SERVICE BULLETIN

APPLICABILITY: 2020-23MY Legacy & Outback
 2023MY Ascent

NUMBER: 07-213-22R

SUBJECT: Genuine Battery Replacement

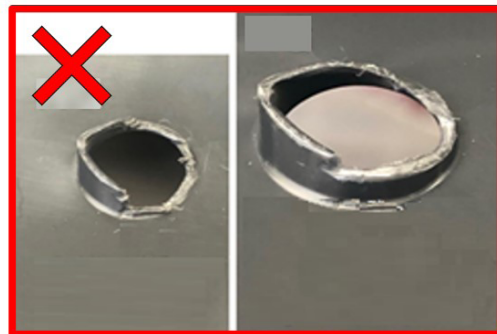
A. CAREFULLY cut off and trim the two protrusions on the bottom of the battery tray. This will allow a proper fit when installed. Try to make the cut as flush as possible.

CAUTION: Be sure the protrusions are trimmed flush. The remaining protrusion height **MUST** be less than 2mm to provide proper fitment.

Remaining Height Is Less Than 2mm

Remaining Height Is More Than 2mm

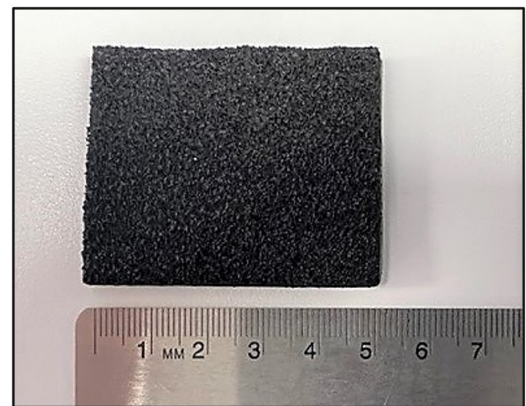
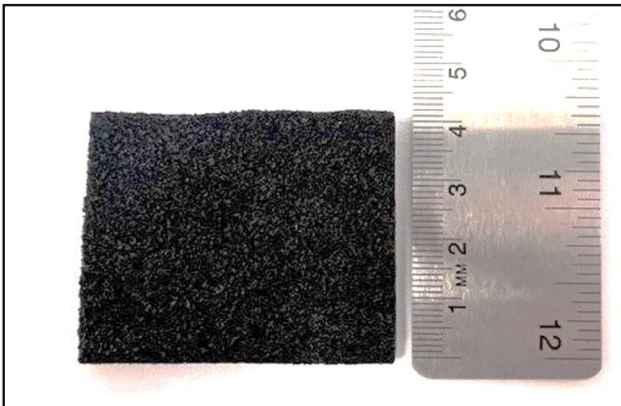
- B.** Remove and the original battery tray. **DO NOT** discard as this must be returned to the customer.

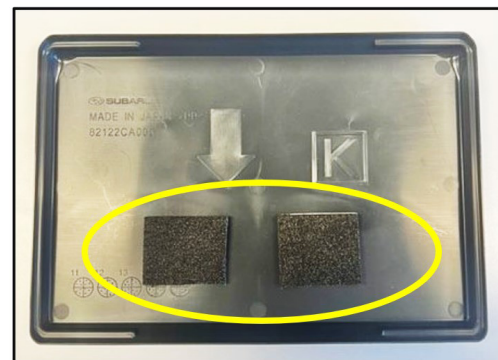
- C.** Prepare two pieces of EPDM neoprene sponge strip. Cut the sections approximately 40 mm tall and 50 mm wide. EPDM Neoprene SBR Strip (item # 6YHD7) supplied by Grainger was used in the example photos below.

- D.** Cover the newly made holes with the two previously prepared EPDM neoprene sponge strip pieces.

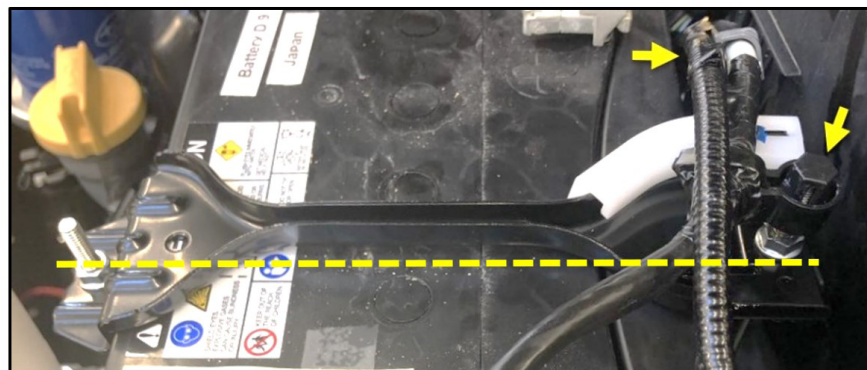
STEP 5: Assemble the new battery holder (p.n. 82184SG000), NEW rear holding rod (p.n. 82161SJ000), and the ORIGINAL front holding rod as shown below. The original rod nut can be transferred to the new rear holding rod.

IMPORTANT: DO NOT discard the original holder and rear rod. These parts are to be returned to the customer.
